APPLICATION FOR PLANNING PERMIT: 54 TO 56 CLARKE STREET, SOUTHBANK	
Application Number:	2013/005973
Proposal:	Demolition of existing buildings on site and development of a multi-storey residential tower, variation of the Design and Development Overlay (DDO60) and clause 52.07 (loading).
Applicant:	Urban Matrix Pty Ltd & Urban Cube Pty Ltd C/- Contour Consultants Australia Pty Ltd
Zoning:	Capital City Zone – Schedule 3 (Southbank)
Overlays:	Design and Development Overlay- Schedule 60 (Southbank Area (DDO60A3)) Parking Overlay Precinct 1 (PO1) Land Subject to Inundation Overlay- Schedule 1 (LSIO1)
Application Received:	21 June 2013
Further Information Requested and Received:	N/A
Number of Objections:	N/A
Recommendation:	Permit

Figure 1 – Proposed Application

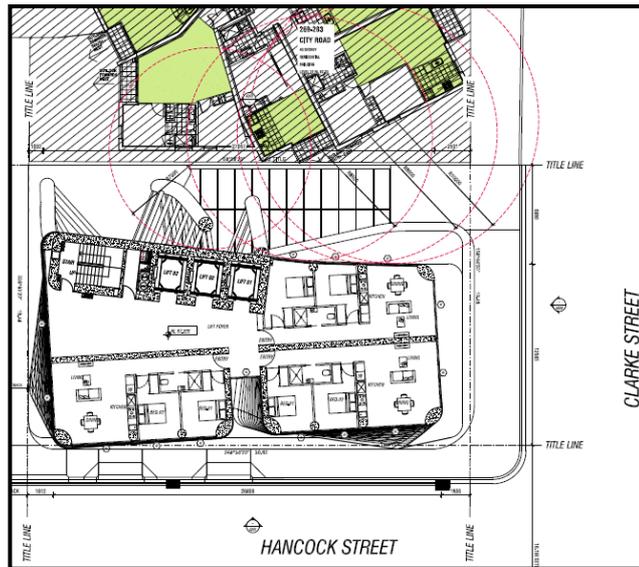
50. The proposed application has been designed in response to the conditions of NOD 2011/008303, including increasing the northern setback to the Bank Apartments. However this has resulted in the inclusion of supporting columns consisting of large concrete pillars designed to support the towers higher levels when the tower form builds out over the northern setback area once the Bank apartments cap out at Level 40 (**shown in Figure 1**).

51. The support columns are within 1 metre of the Bank Apartments and within 3 metres of habitable windows. These columns are considered to be unacceptable as they intrude into the lower northern setback and do not provide for an equitable setback between the Bank Apartments and proposed development.

Figure 2 – Original design

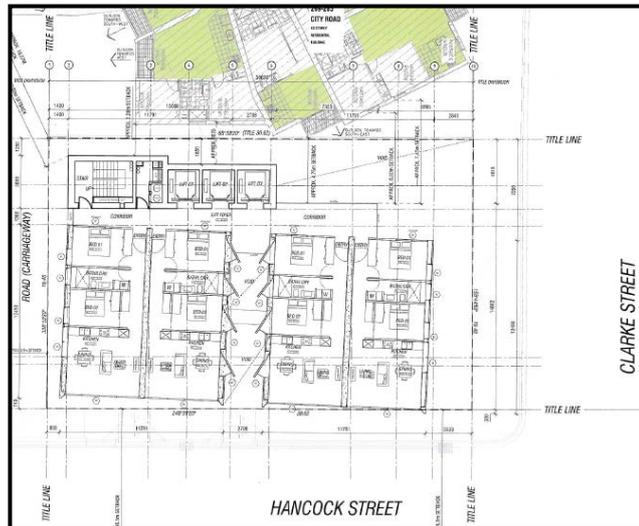
52. The removal of the columns will make the building structural unviable and therefore unbuildable. A better solution will be to allow the building to revert back to its original design with a 2 – 11 metre setback to the neighbouring Bank Apartments and reducing the height to 198 metres (**shown in Figure 2**).

53. This provides for a better design as it removes the perceived cantilevering of the building over the Bank Apartments and provides for a sleeker design that is not reliant on large supporting columns.

Figure 3 – Original design (with setbacks)

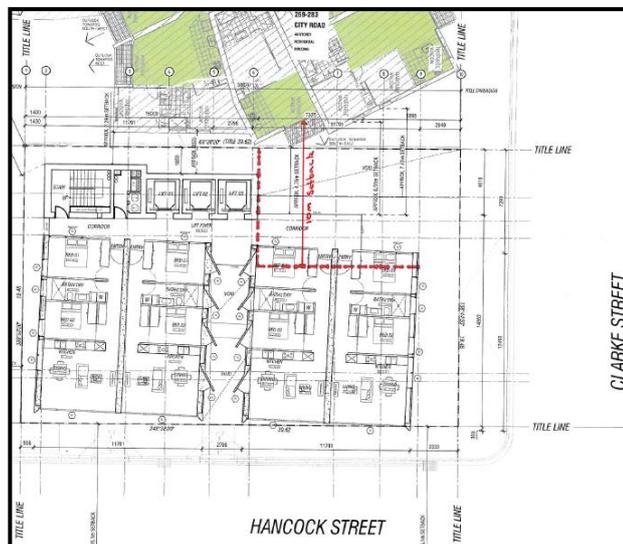
54. Additional setbacks of 8 metres to the northern boundary will be required on the original design to accord with the new setback requirements of DDO60. This will ensure a 10 metre setback to the sensitive living room windows of the neighbouring Bank Apartments (**shown in Figure 3**).
